101.7
THE TEAM
OFFICE
BUILDING

CONCEPTUAL
GRADING AND
DRAINAGE
PLAN

3 OF 5

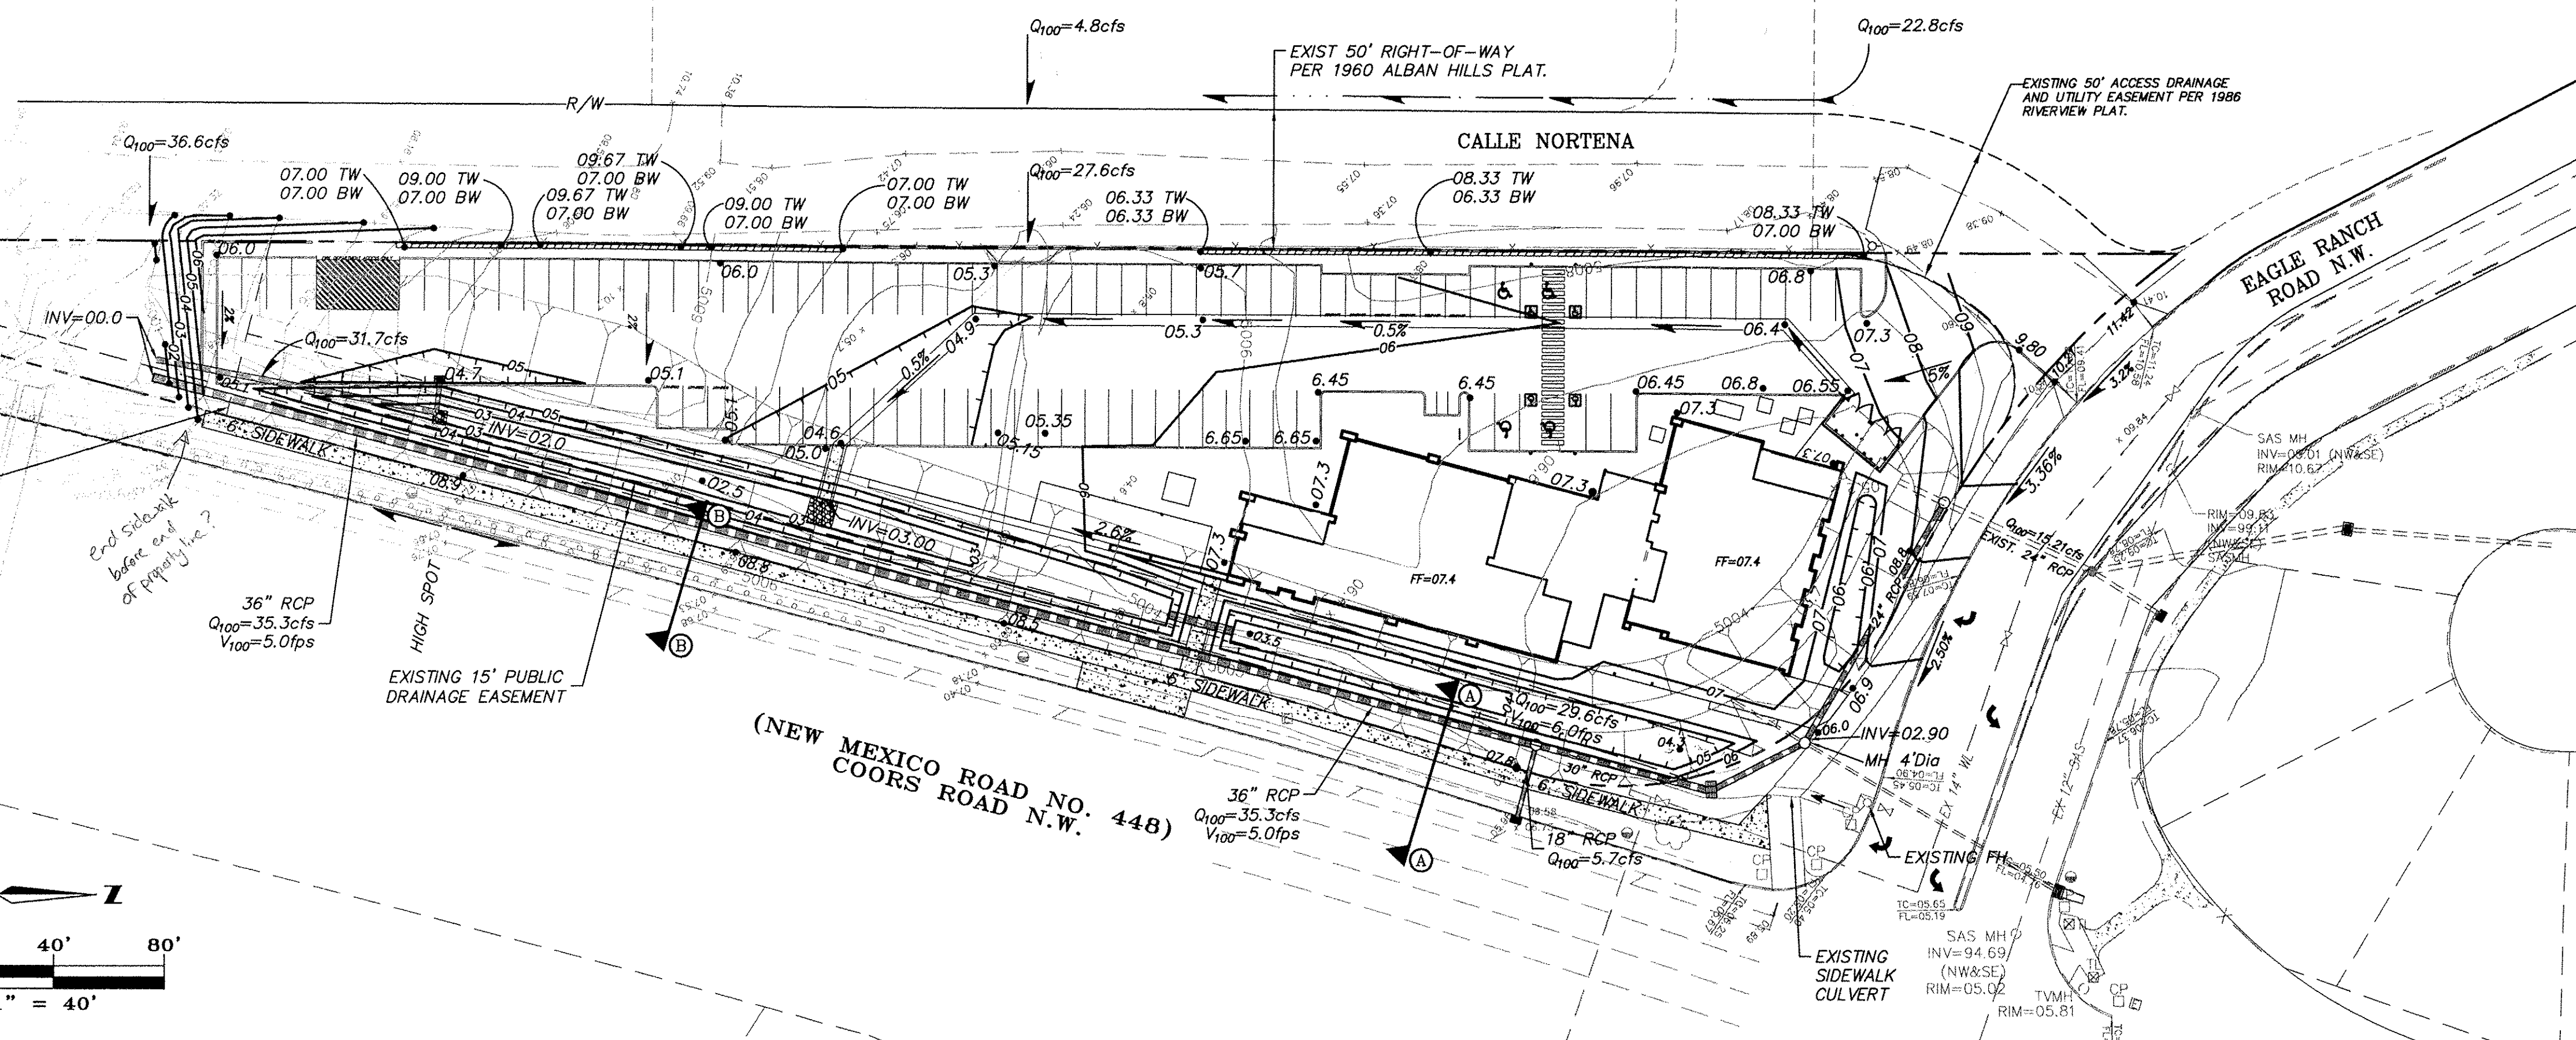
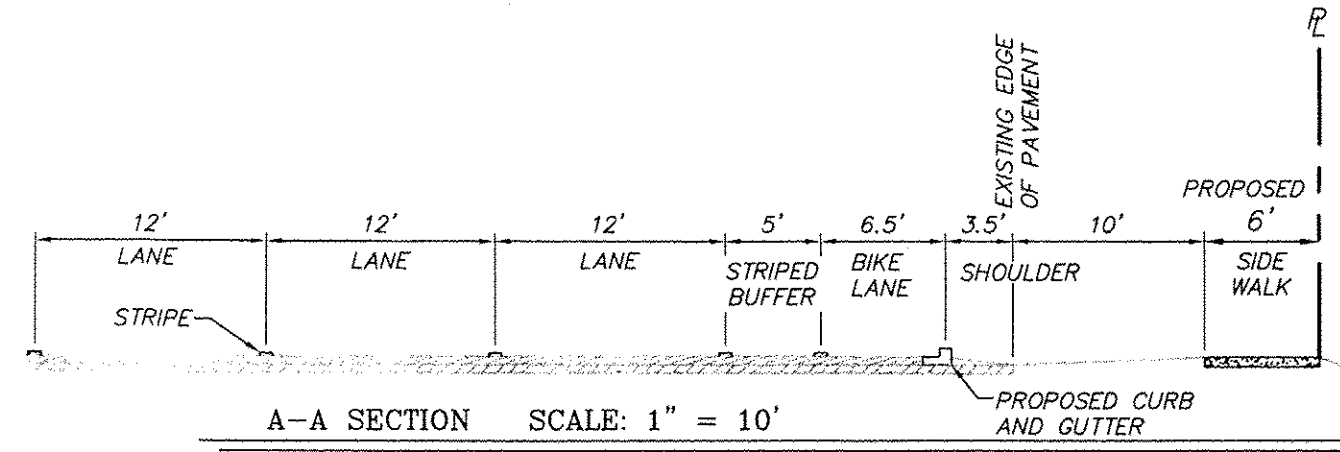
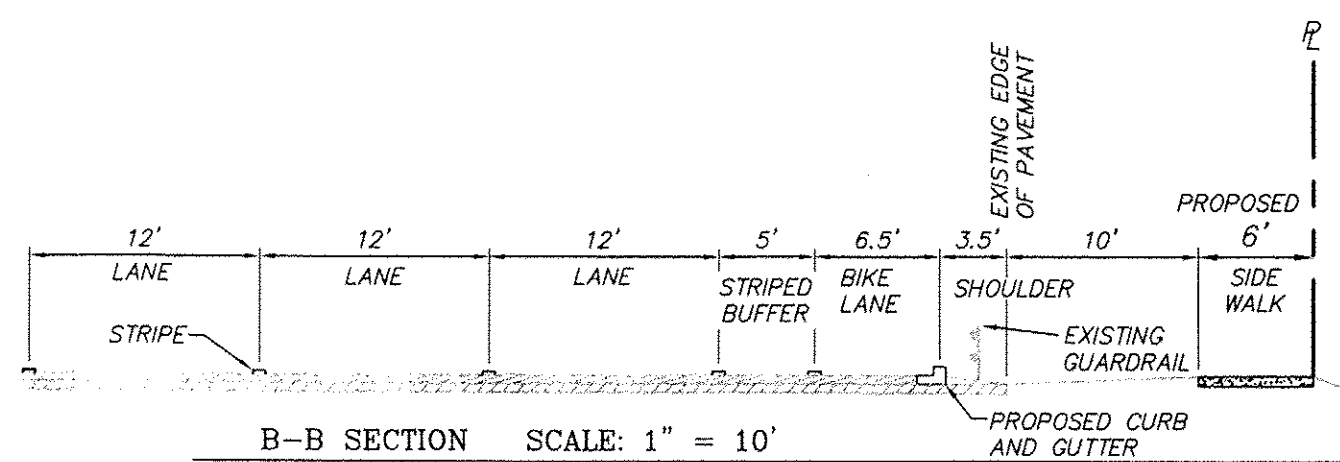
No FIRM
No pond calc's
Not NAVD88
Basin 102 outflow?

- 1) A final design analysis report and detailed construction plans will be submitted to the NMDOT at the time of Building Permit. The final construction plans will include a note that says "A separate NMDOT permit is required prior to construction in NMDOT right of way".

- 2) This project does not include any construction in Bernalillo County's right of way west of this site. Any construction there will be detailed on final construction drawings at the time of Building Permit a will be permitted separately by Bernalillo County Public Works Department prior to construction in the Bernalillo County right of way.

- 3) As stated in note 3 on this Conceptual Grading Plan this site will limit its' onsite storm water discharge to the allowable rate established by the North Coors DMP. Final design analysis will be submitted at the time of Building Permit and will include verification of whether this site falls in Basin 13.1 or 14.1 of that plan.

- 4) The onsite pond size does not need to be increased for sediment because this site will not produce any sediment. There won't be any exposed dirt to cause sediment. All onsite development will be either paved or landscaped. If there is any sediment it can not get through the pond anyway.

- 5) Pond design analysis calculations including pond volume calculations pond construction details will be provided with the construction plans at the time of Building Permit.

- 6) Final design details will address the stabilization of the outfall at the time of Building Permit.
- 7) Sidewalk Culvert details will be referenced on the final construction plans at the time of Building Permit.

- 8) The existing topographic information shown on this Conceptual Grading and Drainage Plan was performed by Aldrich Land Surveying in 2001 and is on NVGD 1929. The survey will be updated on the final construction plans at the time of Building Permit and will reference NAVD 1988 datum. There are not any Special Flood Hazard Zones on or near this site as shown on Flood Insurance Rate Map Number 35001C0116G Revised September 26, 2008.
